To: Village of New Hempstead Planning Board

From: Shelly Karben, 15 Josell Ct

Re: 618 Union Rd Public Hearing

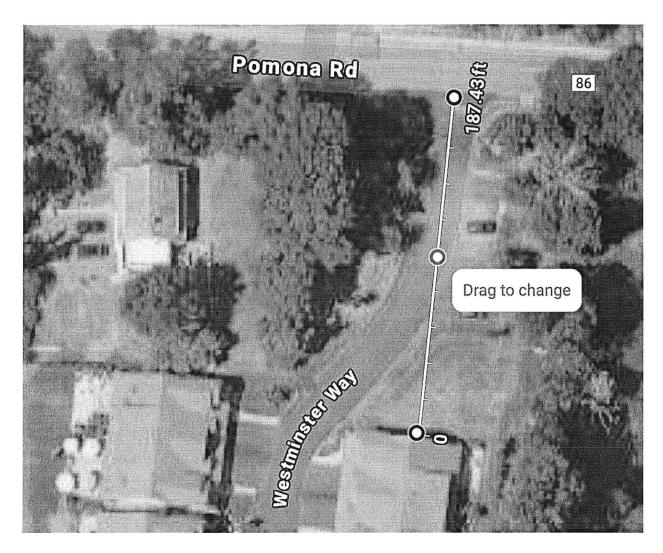
The change in community character is always a problem when introducing non single family homes into the Village of New Hempstead. Here the problem is exacerbated by the extremely limited setbacks being proposed from Union Road that don't provide any room for sidewalks, open space, substantial landscaping to screen and buffer the new development from Union Road.

Currently the natural trees and bamboo in place add to the very rural character along Union Road. The news homes being introduced do not reflect this rural character, they do not match what could be built under 1R-40 and they do not mirror the R-15/R-25 character in place from the old 1962 subdivision across the road.
